**SUNDRY NOTICES AND REPORTS ON WELLS**  
*Do not use this form for proposals to drill or to re-enter an abandoned well Use form 3160-3 (APD) for such proposals*

8 Well Name and No  
NOSLER FEDERAL 2

Burnett proposes to Plug and Abandon this well using the following procedure

**Permanent Abandonment of Federal Wells**  
**Conditions of Approval (LPC Habitat)**

**WELL COMPLETION SKETCH**

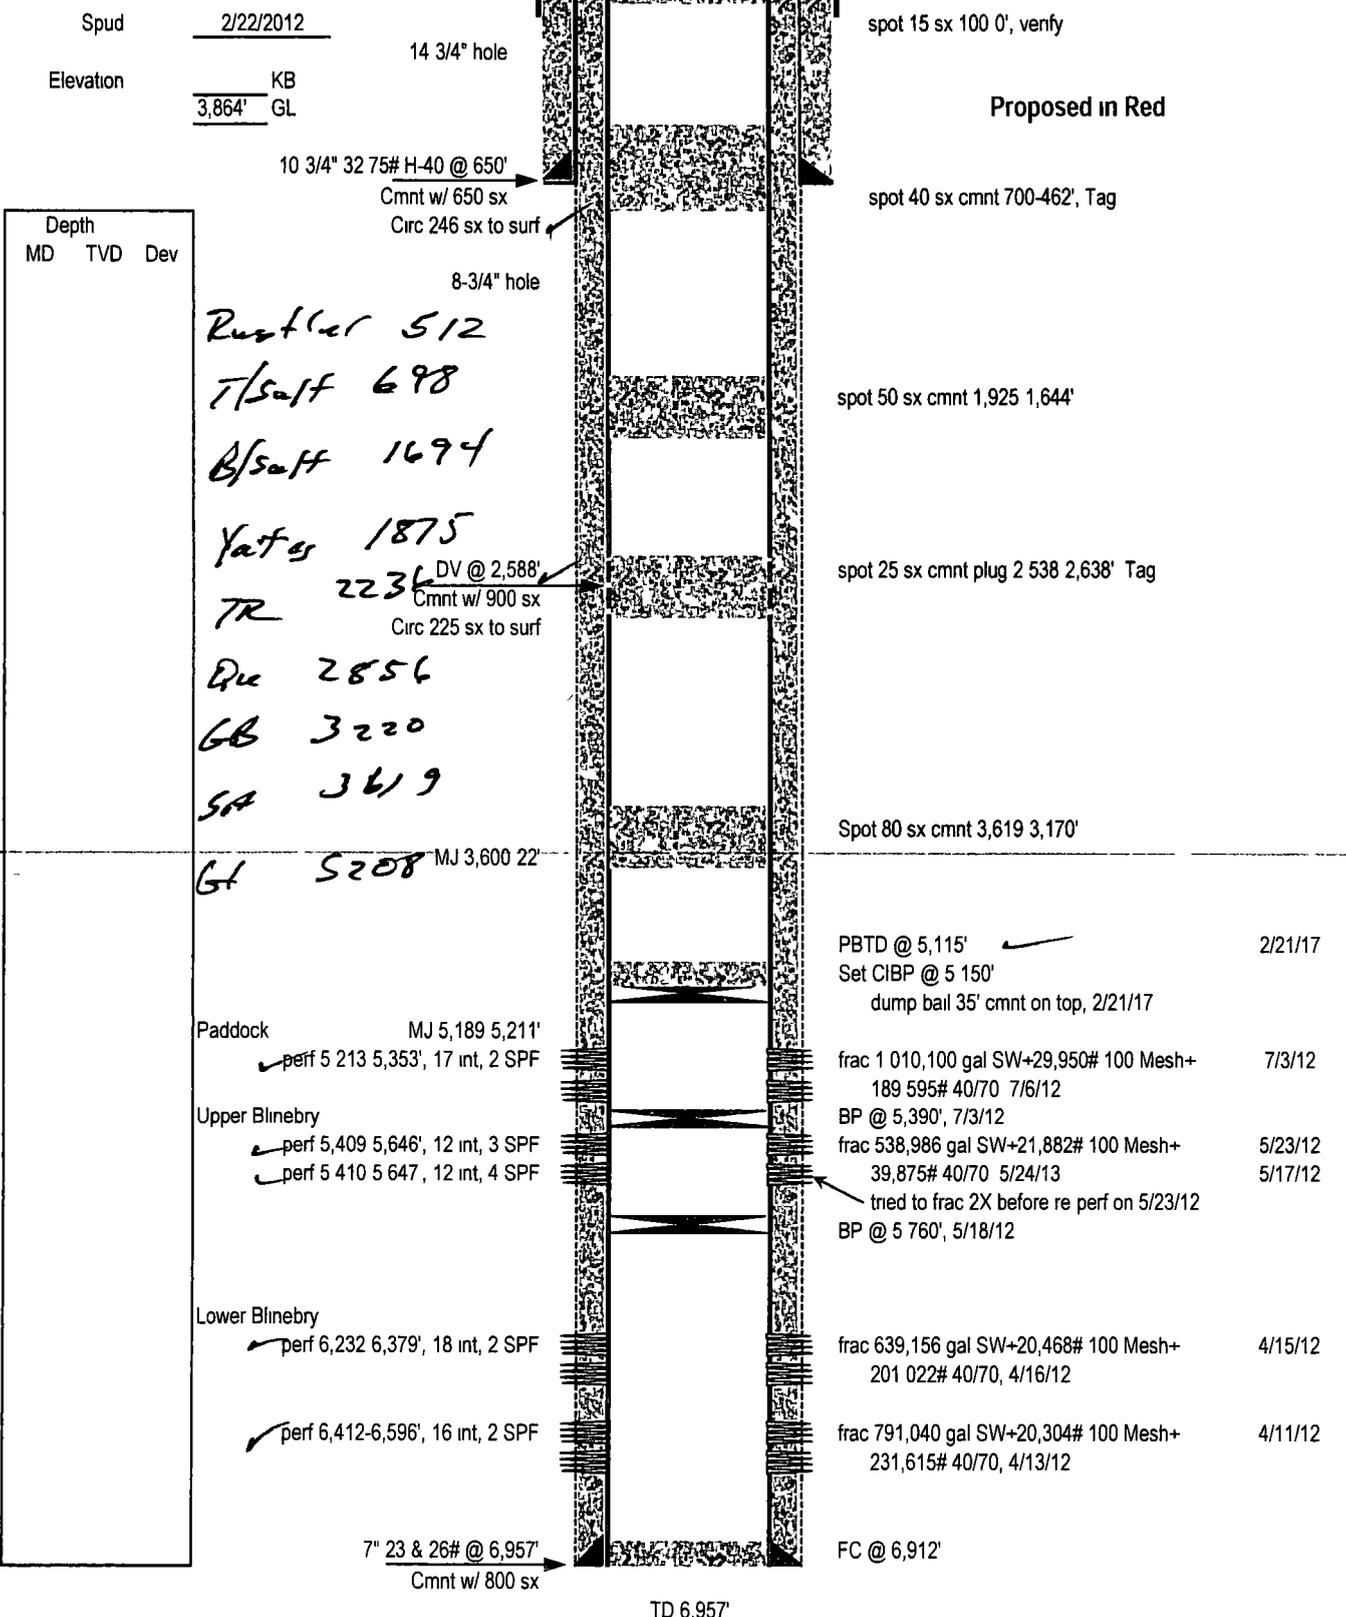
- 1 ) MIRU NDWH NUBOP
- 2 ) Spot 80 sxs @ 36197-3170? 3669
- 3 ) Spot 25 sxs @ 26387-2538? WOC/Tag 130' m
- 4 ) Spot 50 sxs @ 19257-1644? WOC Tag 797-600
- 5 ) Spot 40 sxs @ 7002462? WOC/Tag
- 6 ) Spot 15 sxs @ 1007-0?
- 7 ) Top off well, cut off WH & anchors install below ground P&A marker clean loc

*Below ground level dry hole marker required*
